MIKE CAUSEY, INSURANCE COMMISSIONER & STATE FIRE MARSHAL
BRIAN TAYLOR, CHIEF STATE FIRE MARSHAL

**RE: Occupied Roof and Mechanical Penthouse Related to the 3-Story Limit of the NC Residential Code
2018 NCRC R101.2**

This letter is in response to your request for formal interpretation dated August 18, 2021 that was received in NCDOI by email on that same date. Your request for formal interpretation states in my words:

For Project – Anderson St Townhomes

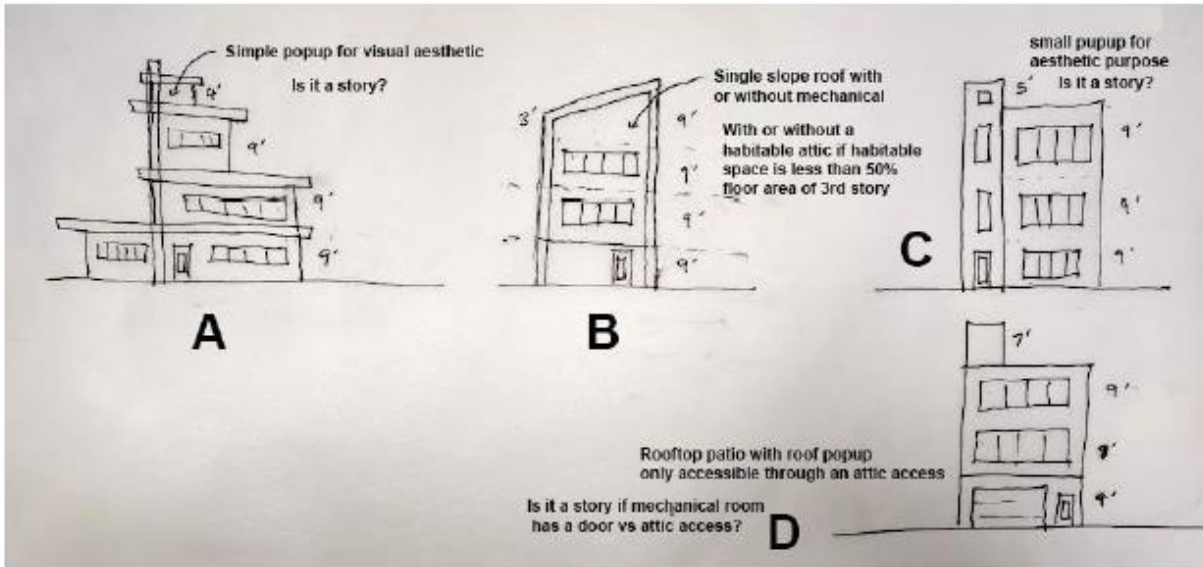
My understanding is that code officials are allowed to reference the NCBC for clarifications on things not clear in the NCRC. If this is correct and the question is whether or not a mechanical penthouse is a story or not then the NCBC has an exception excluding it from being a story. Even if I submitted to commercial plan review using the NCBC and used this exception it would be considered a 3 story building and per 101.2 of NCBC it shall comply with the international residential code (assuming NCRC). My interpretation of this leads me to believe that Mecklenburg county FORCING this to be reviewed using the NC Building Code by the commercial review team is non compliant with the above code sections. I also interpret this to mean a mechanical space with a man door access would be allowable in lieu of an attic access. This would be a preferred method for maintenance of the mechanical unit.

SHEET NAME
 FLOOR AND ROOF
 PLAN

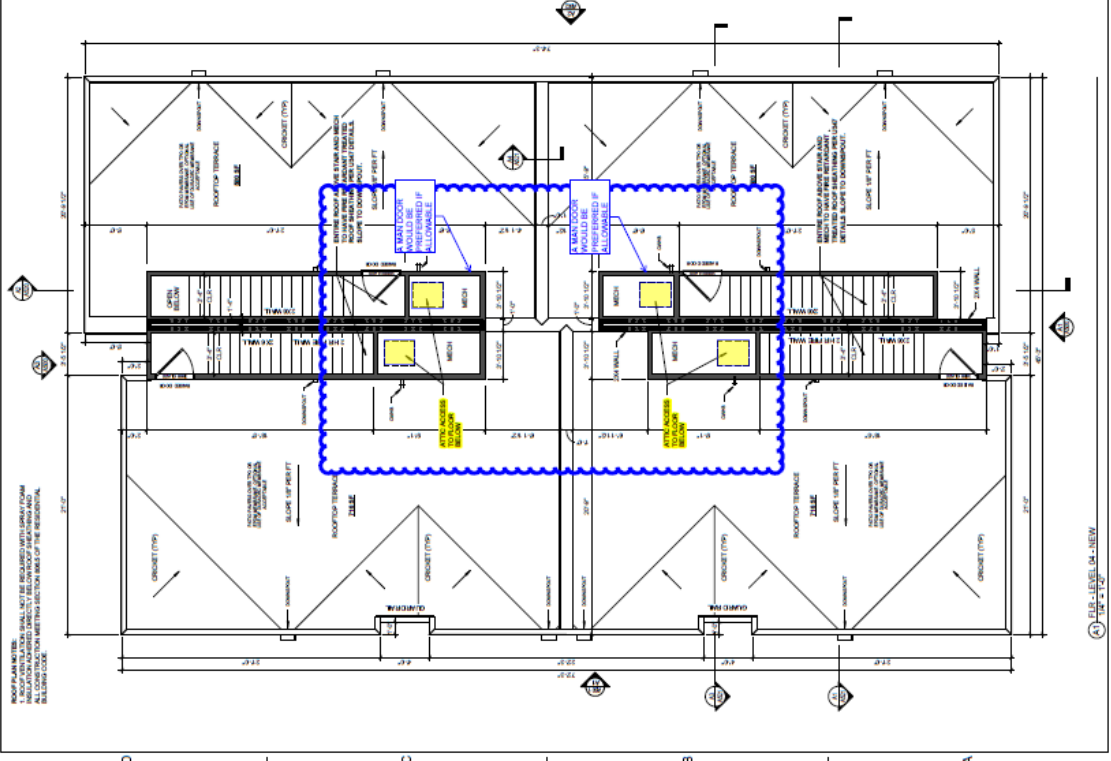
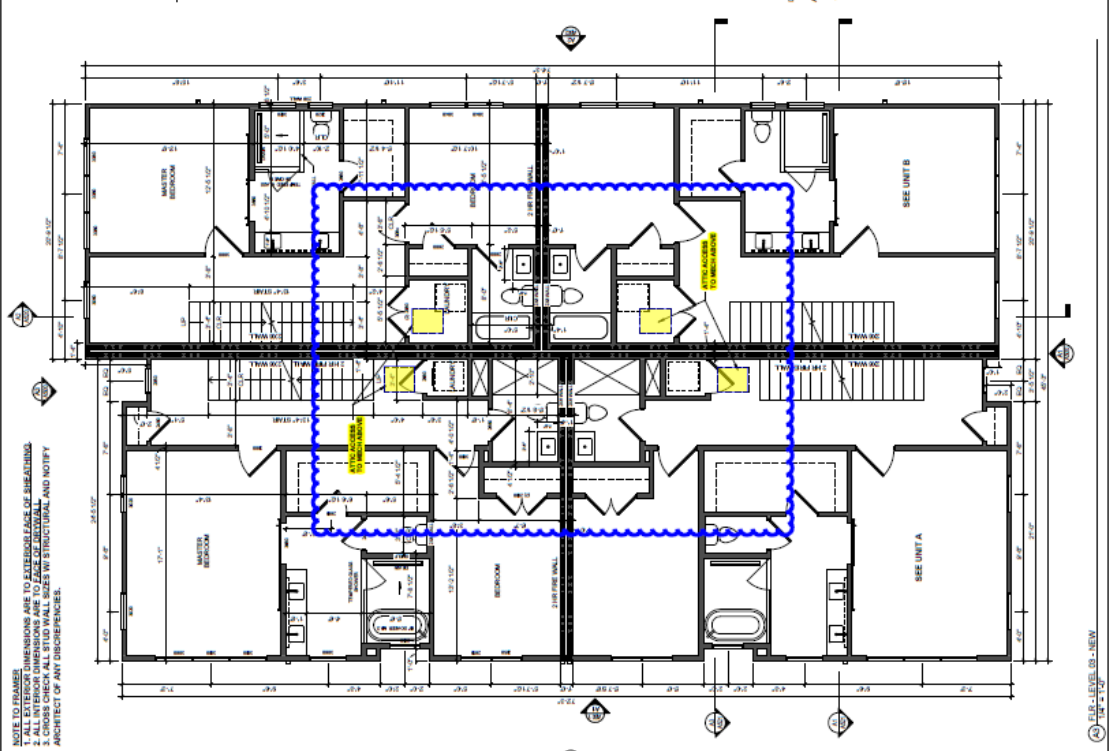
I have designed this 4 unit townhouse with an accessible rooftop and a mechanical space next to the stair towers as shown in the plans. I have only included sheets I thought would be relevant to your interpretation. The mechanical space is unfinished and only accessible via ceiling attic access from the 3rd floor. In this design I have interpreted this to be an attic with attic access per evidence listed below. It could also be designed so that there is a door entering the mechanical room from the rooftop rather than an attic access. This would be easier and safer for maintenance. In this configuration it would be considered a mechanical penthouse as defined in the NCBC.

Comments: The proposed design in attachment A appears to comply with the requirements of 1510.2.1 through 1510.2.5 which would make the proposed design a 3-story building with a penthouse and thus able to use the NCRC.

Based on the evidence of the above referenced code sections, an occupied roof or a mechanical penthouse are not considered a story with regards to applying the NCRC. However, the structure of a 3-story dwelling with a penthouse or occupied roof above the 3rd story is required to be engineered because:
